**TOWN OF MOUNTAIN VILLAGE
REGULAR DESIGN REVIEW BOARD MEETING **REVISED 2** AGENDA
THURSDAY JULY 7, 2022 10:00 AM
MOUNTAIN VILLAGE TOWN HALL
455 MOUNTAIN VILLAGE BLVD, MOUNTAIN VILLAGE, COLORADO
TO BE HELD HYBRID THROUGH ZOOM:**

**DESIGN REVIEW BOARD MINUTES
TOWN OF MOUNTAIN VILLAGE REGULAR
DESIGN REVIEW BOARD MEETING
THURSDAY JUNE 2, 2022**

FROM: John Miller, Principal Planner
Amy Ward, Senior Planner

02 SOUTH ELEVATION
SCALE: 1/4"=1'-0"

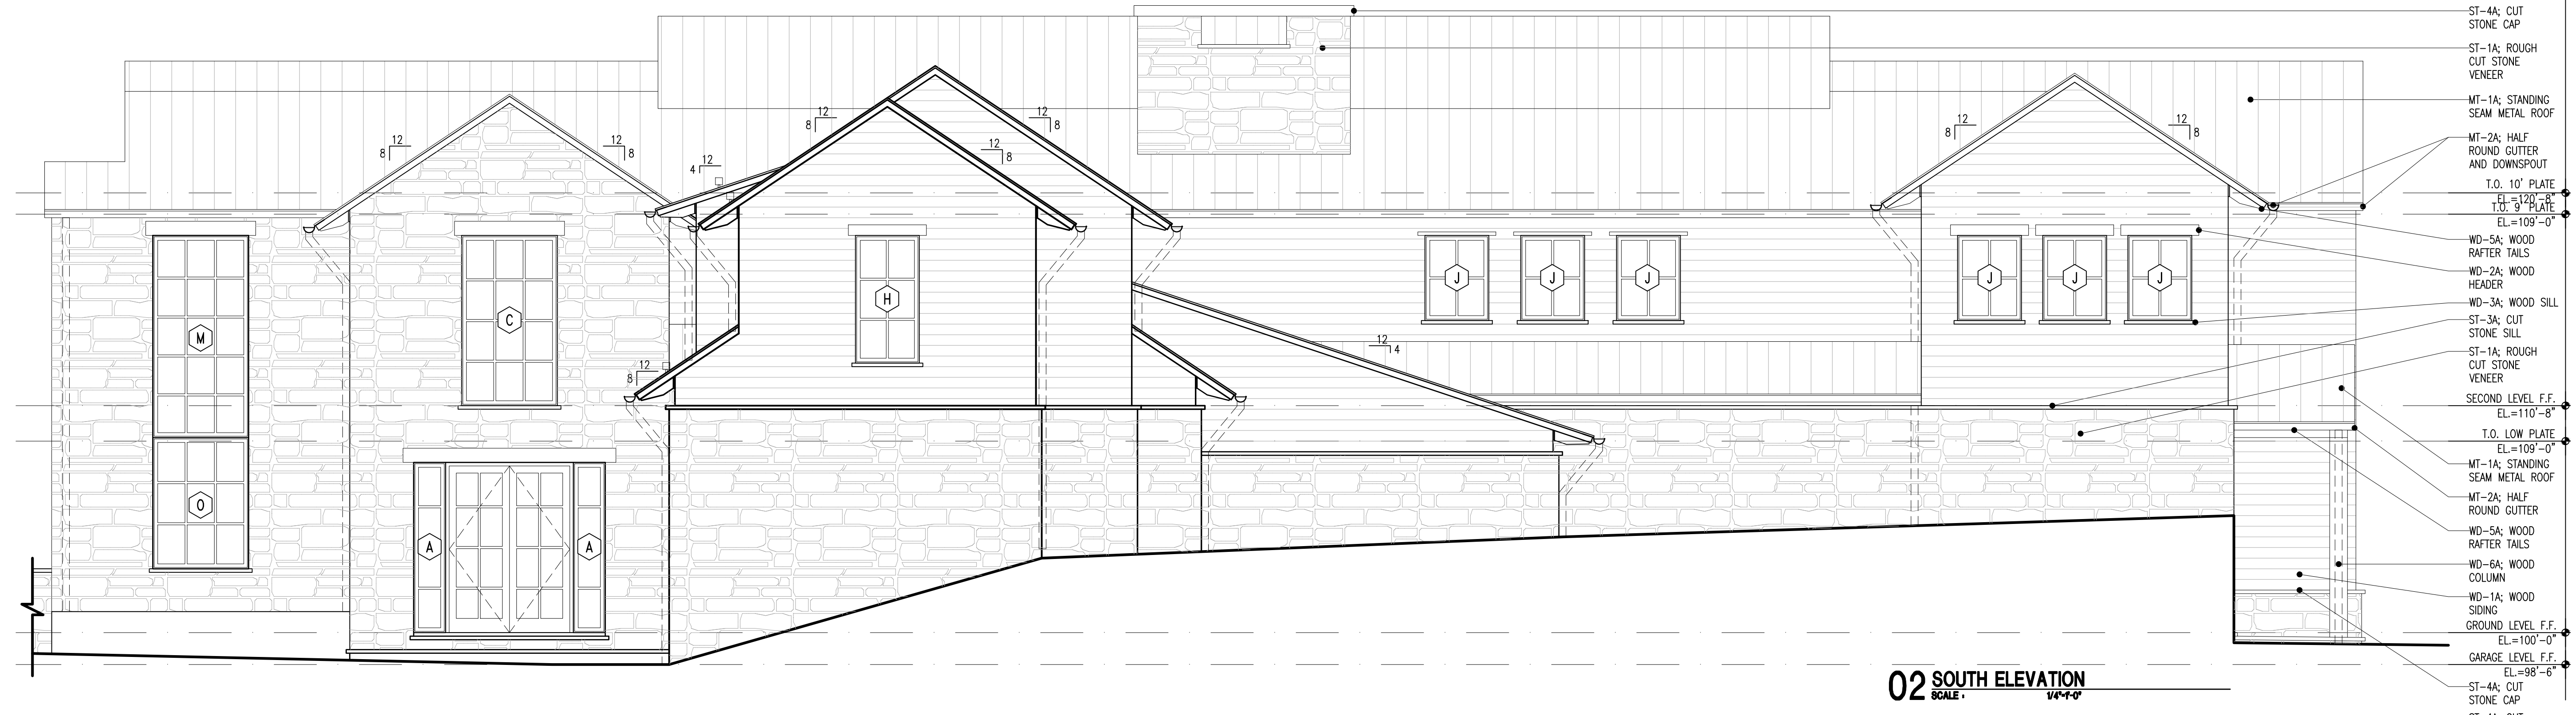
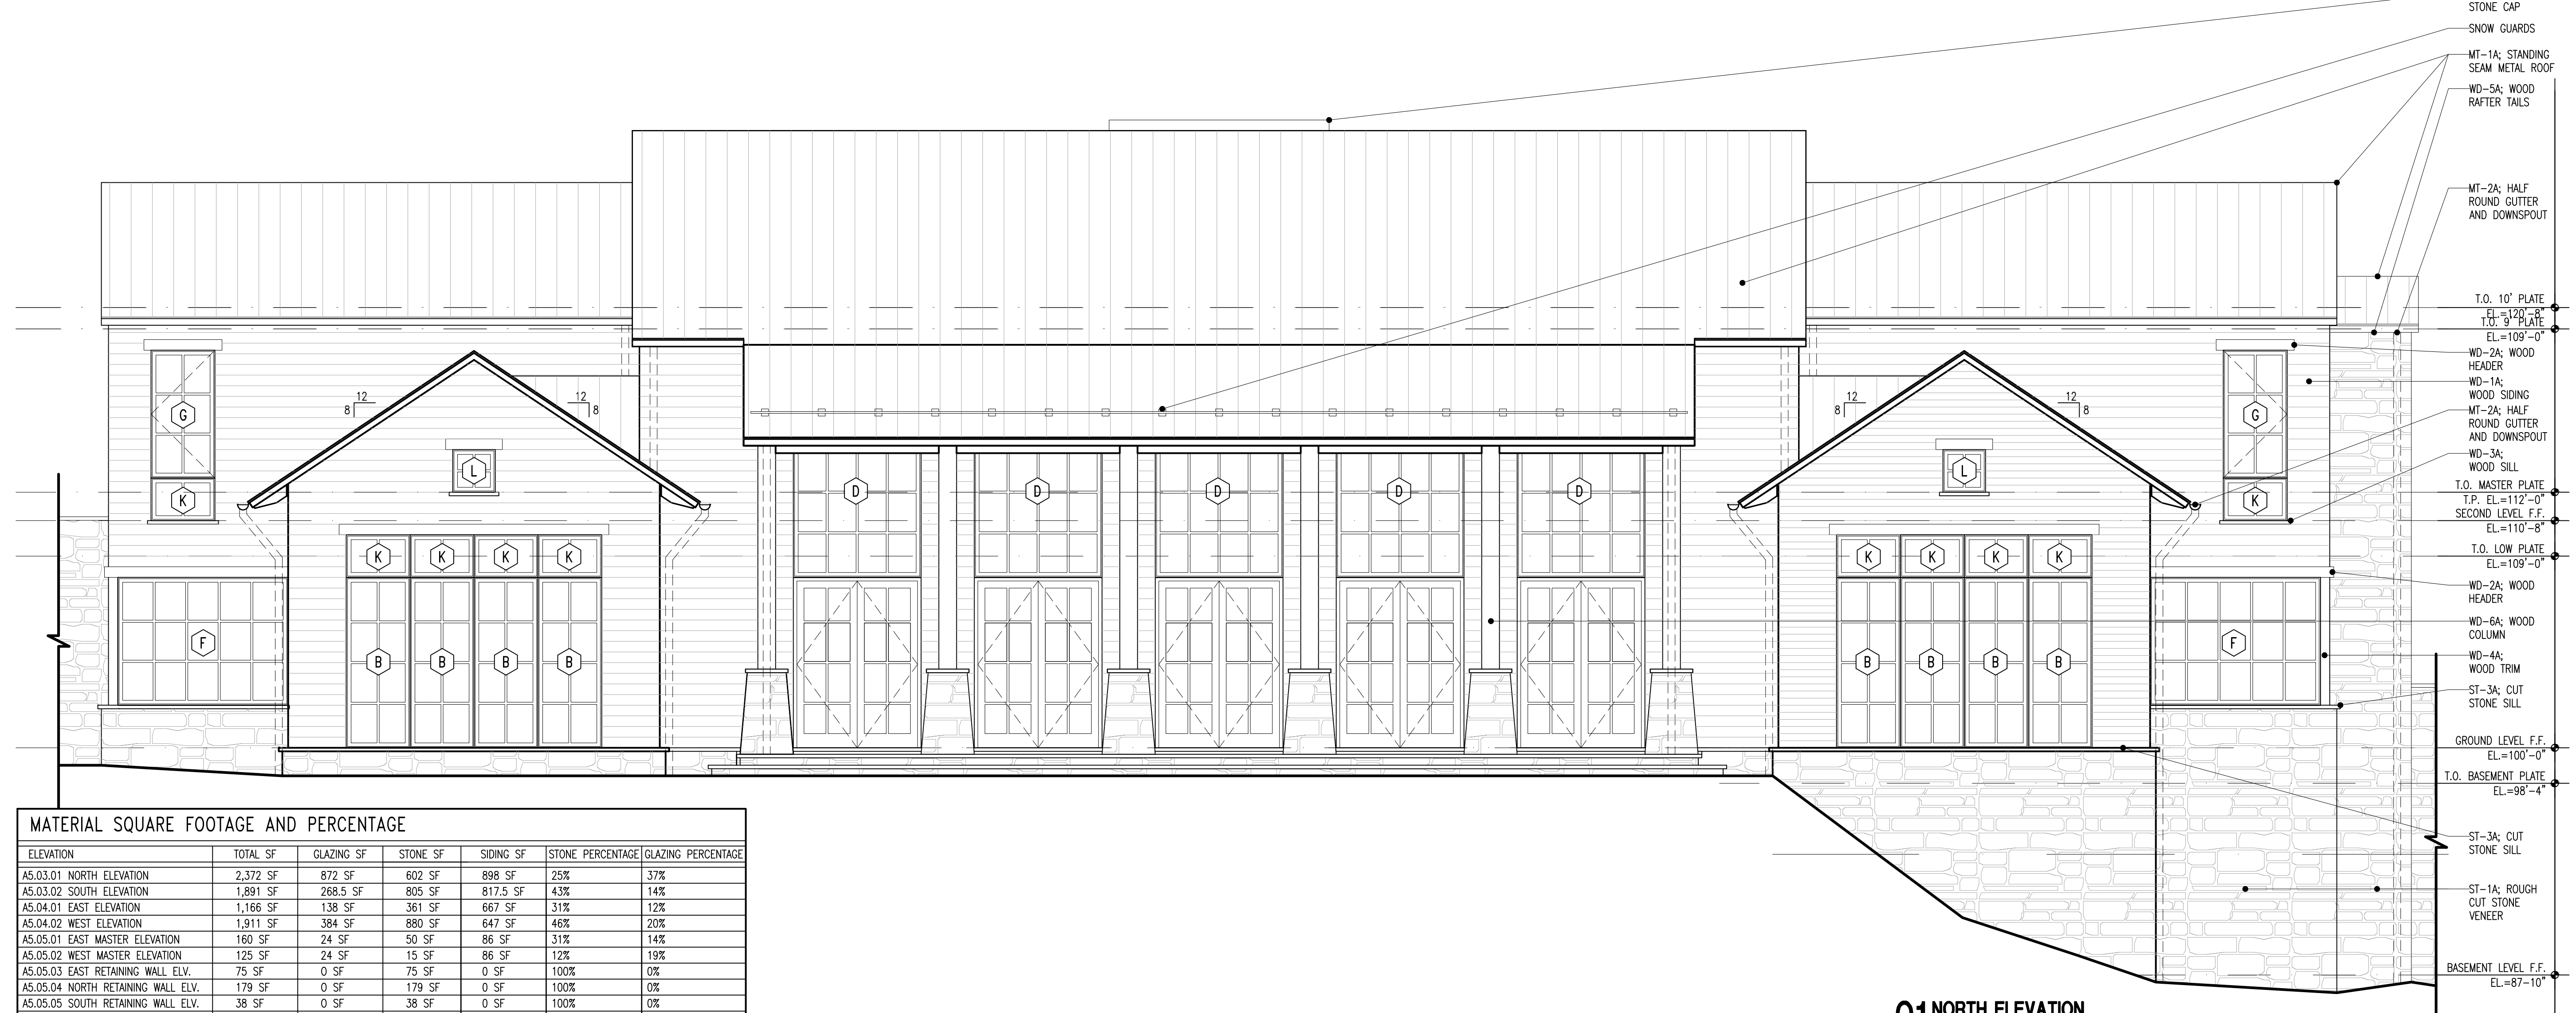
1. Prior to final review, the applicant shall revise the parallel plane diagram per the requirements of the CDC to demonstrate that no portion of the home penetrates the 40-foot plane reflecting the most restrictive adjacent grade. Height plane diagrams are shown on Sheets A5.06 and A5.07.
